Re: Indian Point Unit 3  
Docket No. 50-286  
NL-04-156

**Subject: Reply to RAI Regarding Indian Point 3 Stretch Power Uprate dated  
November 5, 2004 (TAC MC 3552)**

- Attachment 1: Summary Listing of RAI Responses Regarding Stretch Power Uprate License Amendment Request for Indian Point 3
- Attachment 2: Additional Information for IP3 SPU License Amendment Request, Based on NRC RAIs Issued November 5, 2004.

Figure RSA-8-1 RCSL Figure from Draft IP3 Cycle 14 COLR

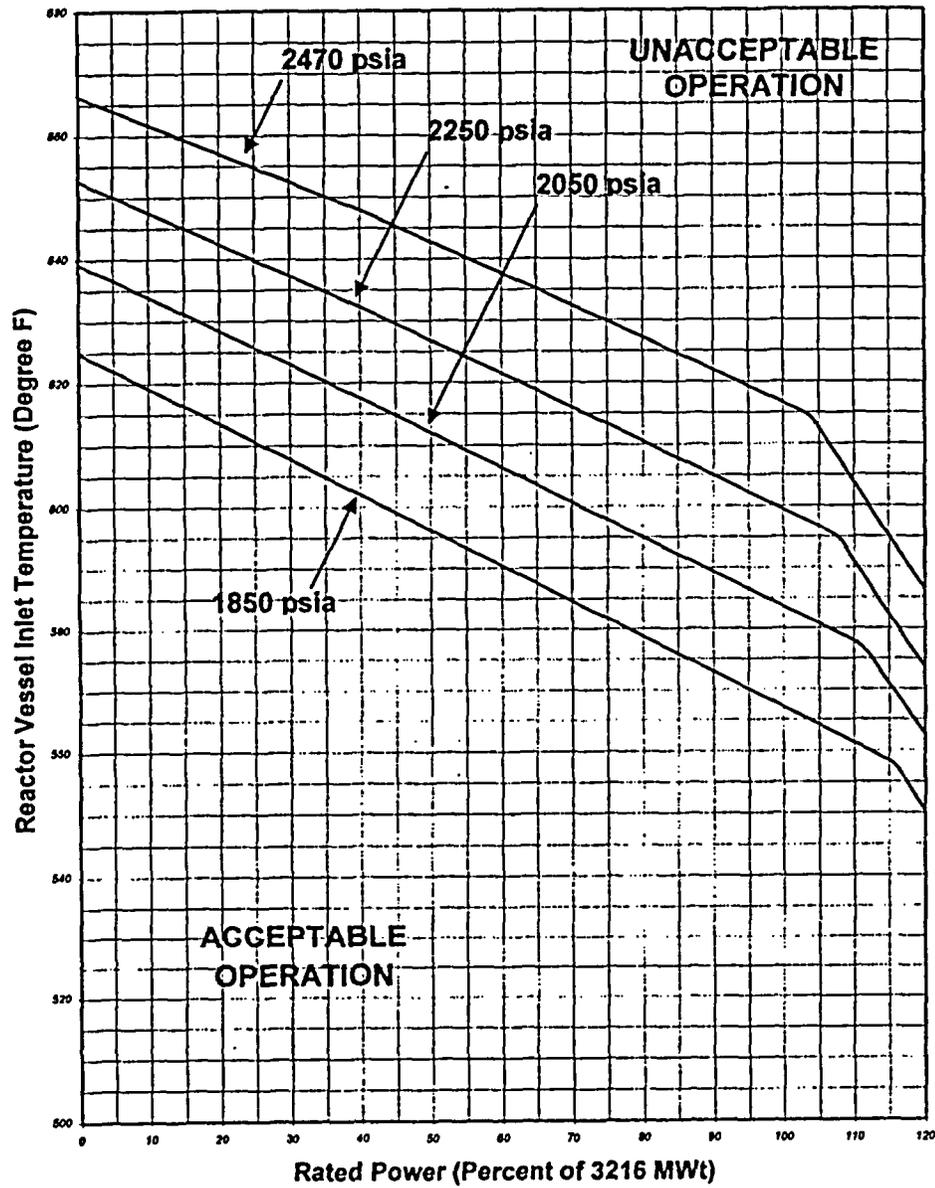
Many cycle-specific parameters have been relocated to the core operating limits report (COLR), which was not submitted with the application. These include the Reactor Core Safety Limit (RCSL) figure, the values of the constants in the Over-temperature and Over-power  $\Delta T$  functions, respectively (Notes 1 and 2 in Table 3.3.1 1), and the limit values of the pressurizer pressure, RCS average temperature, and RCS total flow rate (limiting condition for operation (LCO) 3.4.1).

Provide the RCSL figure and the values of the constants of the OT $\Delta T$  and OP $\Delta T$  functions, and the RCS flow, average temperature and pressure limit values in the COLR, or confirm that they are the same as those provided in the application report.

A response to this question (except for the RCSL figure) was provided in letter NL-04-145 of November 18, 2004, in Attachment 2 in response to IP2 item NL-04-073-RSA-20. That response is provided below. The RCSL figure is provided as Figure 6.3-1 of WCAP-16212-P and WCAP-16212-NP and here as Figure RSA-8-1.

Figure 1

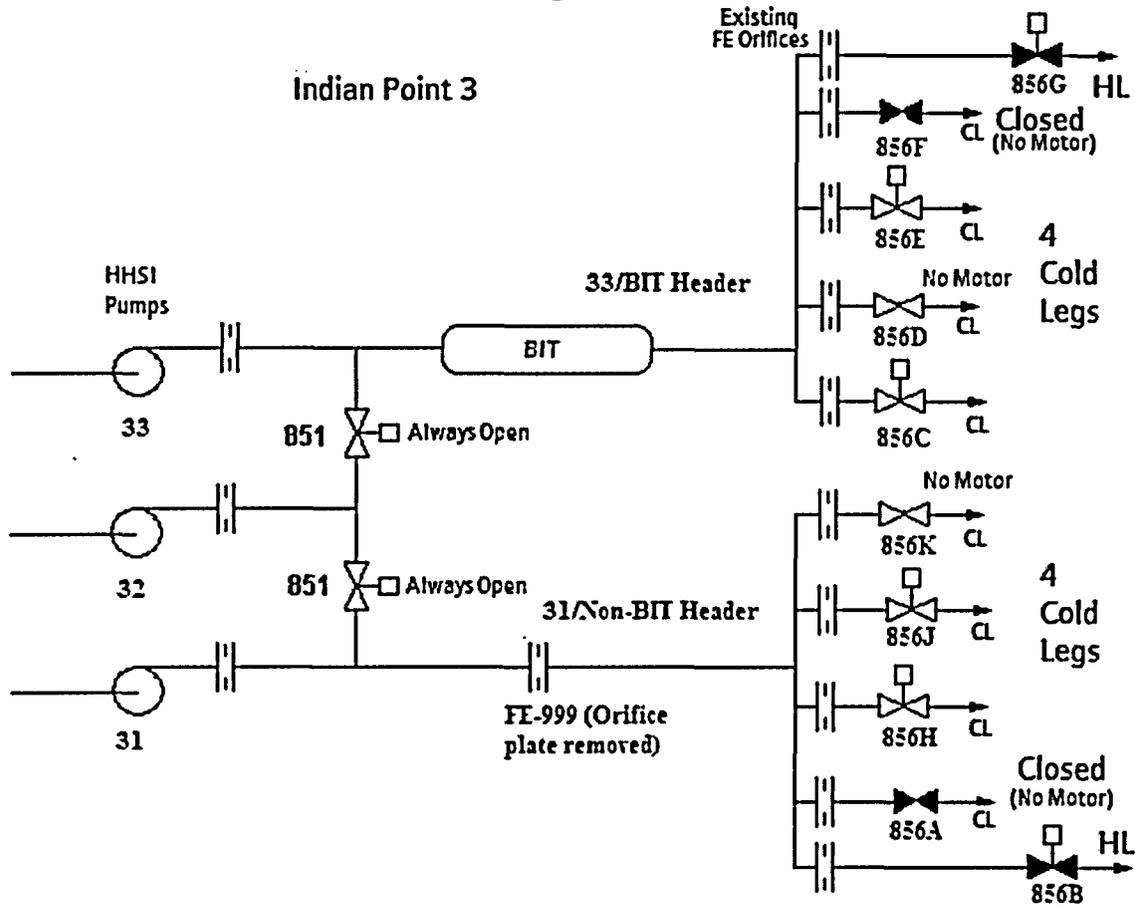
In Section 4.1.4 on the safety injection system/containment spray system of application report, the licensee states the high-head safety injection (HHSI) system was modified by permanently closing two cold leg branch lines, and throttling the HHSI system to provide higher cold leg and hot leg flows. What is the design function of the branch line? Why is it acceptable to defeat this

function permanently? Provide a system diagram which depicts the branch lines that were closed. Discuss how this is administratively controlled and how the redundancy and independence of the system was preserved.

**Question:** Provide a system diagram which depicts the branch lines that were closed.

Figures 6.2-1A and 6.2-1B are system diagrams provided in the Indian Point 3 UFSAR. A simplified figure of the system, showing the lines that are closed, is provided as Figure RSA-12-1 attached.

**Figure SI-1b-1: Probability of Correct Rejection/Reporting (PCR) Considering Only Passed Candidates, Appendix VIII from the Outside Surface. Reporting Criterion A' = 0.15 inch.**

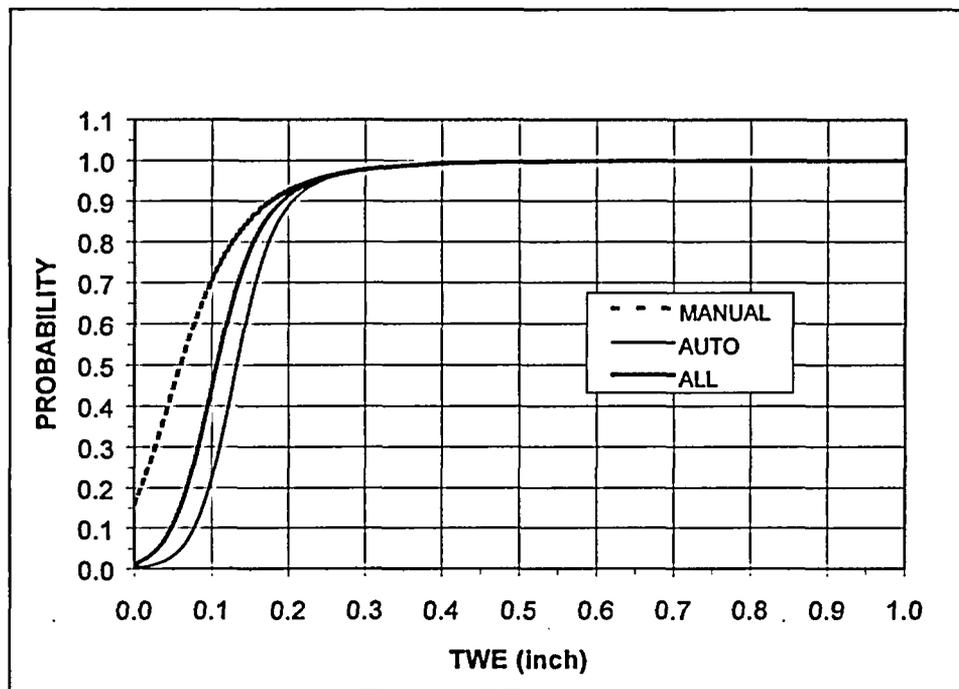
PVM-1 also requested the licensee to justify the use of a smaller flaw size for the RV outlet-nozzle-to-shell region. Table 5.9-4 of the IP3 application report indicates that smaller flaw sizes than those specified in Appendix G of Section XI of the ASME Code were used for the steam generator tubesheet and shell junction, steam outlet nozzle, and feedwater nozzle. Provide a justification for using the smaller size flaw or provide an analysis using the flaw sizes and margins described in Appendix G of the Section XI of the ASME Code.

The PODs for the steam generator tubesheet and shell junction, steam outlet nozzle, and feedwater nozzle can be taken from EPRI Report, "Justification for the Reduction of Inspection Requirements for the Boiling Water Reactor Nozzle-to-Vessel Shell Welds And Nozzle Blend Radii (VIP-108)", R. Carter, June 2002. This report is deemed applicable as the inspection technique would be the same for Steam Generators and applicable for regions with wall-thickness less than 11 inches. As shown in the following figure, the PODs of flaws with depth greater than 0.5-inch is approximately 100% (manual OD volumetric).
